**Great River Hydro**

March 29, 2021

**Re: Great River Hydro, LLC; FERC Project Nos. 1855-050, 1892-030 and 1904-078  
Response to License Application Additional Information Requests**

**AIR 4, Figure 1. Detection zone of monitoring station downstream of Vernon Dam. Receiver location designed for ILP Study 21 (American Shad Telemetry) in 2015.**

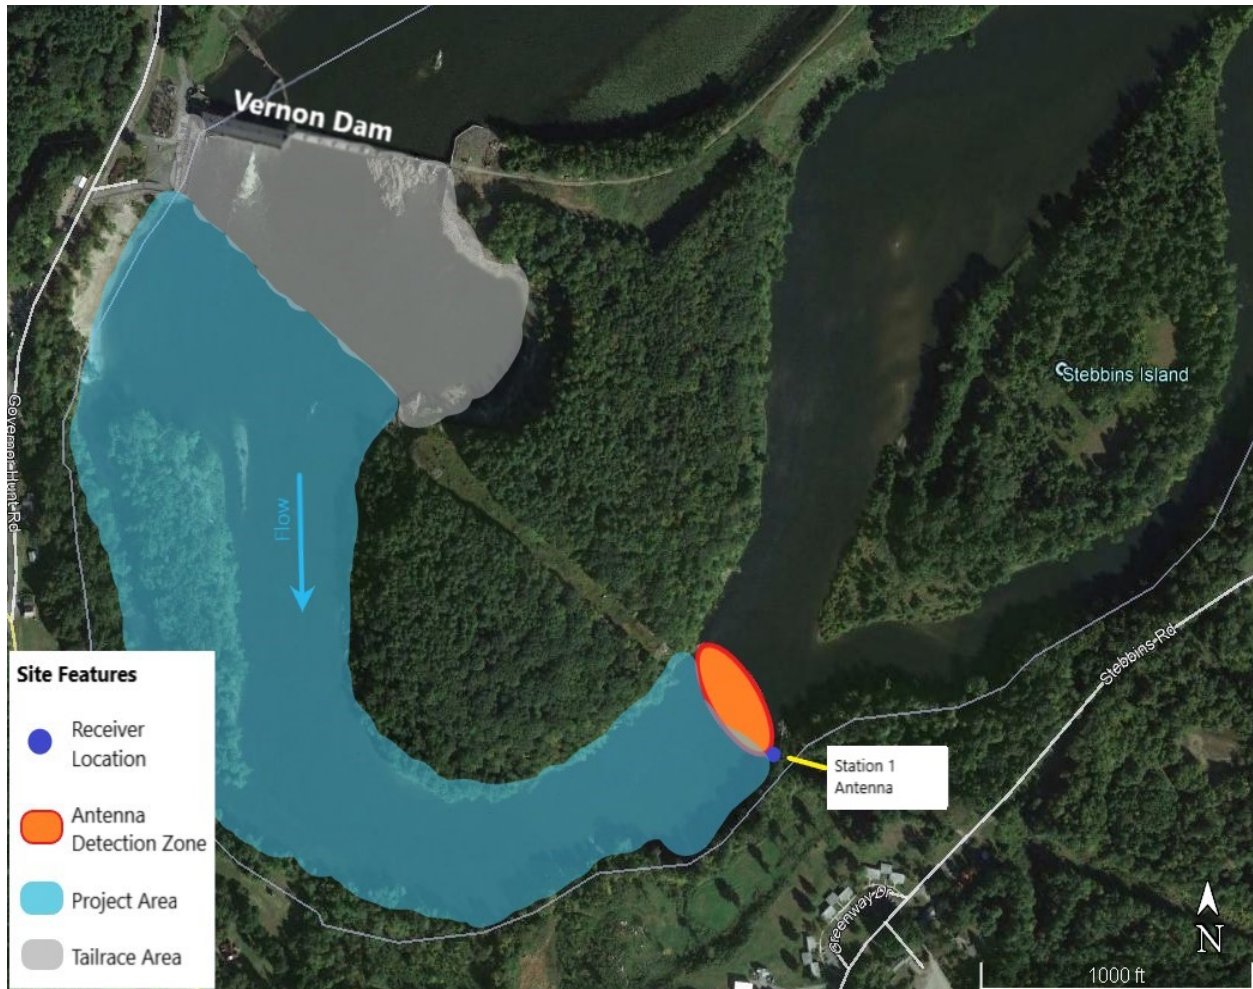
**AIR 4.** In section 3.6.2.7 of Exhibit E, Great River discusses observations of adult sea lamprey utilizing the upstream fish passage facility at the Vernon Project (n = 2,440) in 2015. In Study 16 (Sea Lamprey Spawning Assessment),<sup>1</sup> Great River states that 18 of the radio-tagged sea lamprey from FirstLight's Turners Falls Hydroelectric Project and Northfield Mountain Pumped Storage Project relicensing studies were subsequently detected at the Vernon Project. Please confirm the total number of radio-tagged sea lamprey that utilized the Vernon Project's fish ladder, the date/time they were first detected near the ladder entrance, the data and time they entered the ladder, and the date/time they exited the ladder.

Monitoring stations used during the American shad telemetry study at Vernon are presented in Figures 1 and 2. Descriptions and functionality for each of the monitoring stations during the fish passage study period are described within the ILP Study 21 report. The fishway monitoring stations in ILP Study 21 (Figure 2) were set up with both PIT and radio receivers to evaluate upstream passage efficiency for American shad. Unlike the dual-tagged American shad released as part of Study 21 (i.e., individuals
